Development Permit Panel

2. Development Permit 10-538908

APPLICANT: Doug Massie, Architect of Chercover Massie & Associates Ltd.

PROPERTY LOCATION: 8851 Heather Street

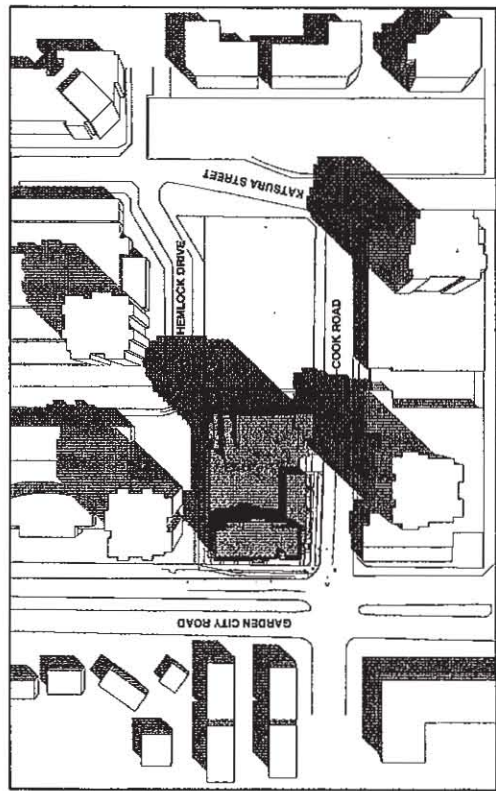
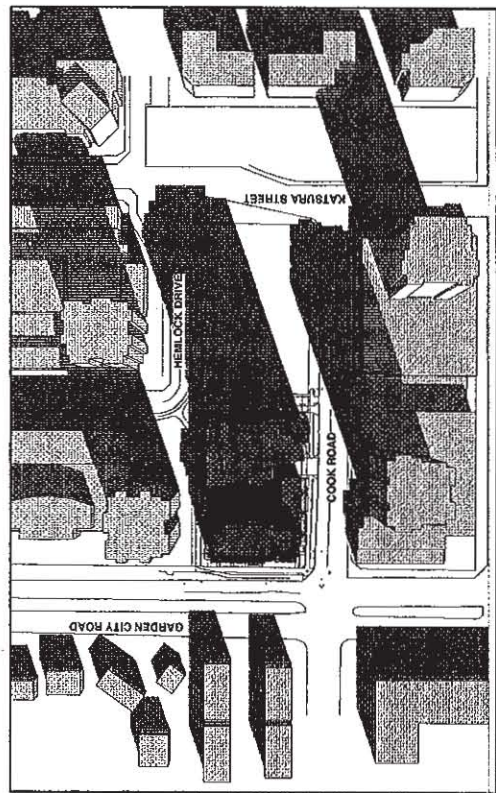
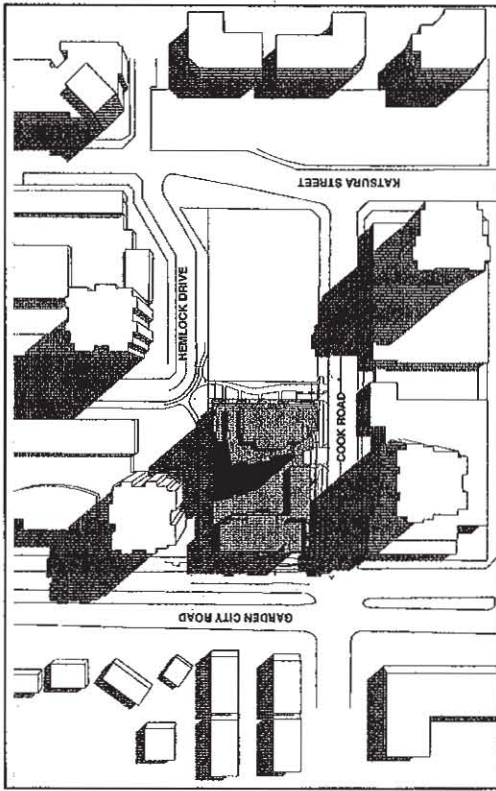
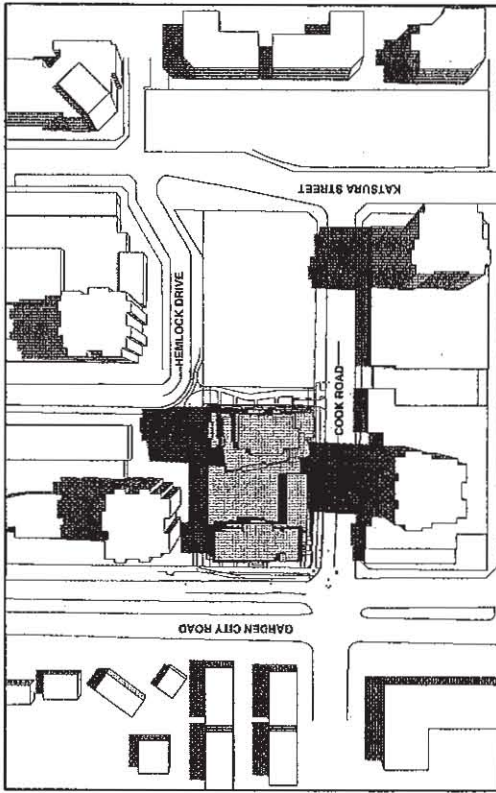
3. ***design development to the mid-rise corner at Cook Road and Garden City Road and consider i) adding a water feature, ii) raising the parapet, and iii) introducing public art; and***

Applicant Response: Landscaping at this corner has been redesigned to provide a pedestrian level open space complete with public seating. A project-theme inspired art piece, to be located at this corner, will be commissioned and will be coordinated through the City's Public Art Program. Lighting will be provided under the lobby canopy to highlight the building entrance. Currently, the roof parapet of the corner massing is already higher than the rest of the midrise. The midrise entry has been redesigned to provide a grade level public seating area and enhanced pedestrian experience. A sculptural art piece that will reference the Monet theme will be commissioned. Additional lighting will be provided to highlight

the entry.
